# La Marzocco Technical Bulletin #108

## Barista Light Kits

### Barista Light Kit

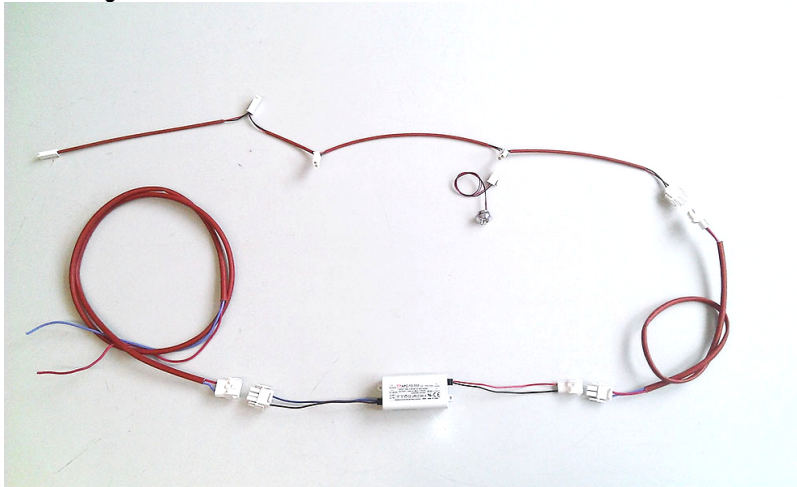
We are pleased to inform you about the introduction of a new barista light kit, which includes a new transformer and wiring system.

All cables are equipped with new connectors, making new installations or replacing single sections easier. When updating from the old transformer to new transformer, it may be necessary for technicians remove the previous wire connector and in its place use:

This kit should only be installed on machines originally equipped with barista lights.

Please note that the E.4.023.02.R is composed of one single led light (and the washer). Therefore, in order to get a complete kit for a 3 group machine, you should order:

- n.1 E.4.021.01
- n.1 E.4.024.01.R
- n.6 E.4.023.02.R

Be advised that two transformers and two wiring looms are necessary for a 4-group machine.
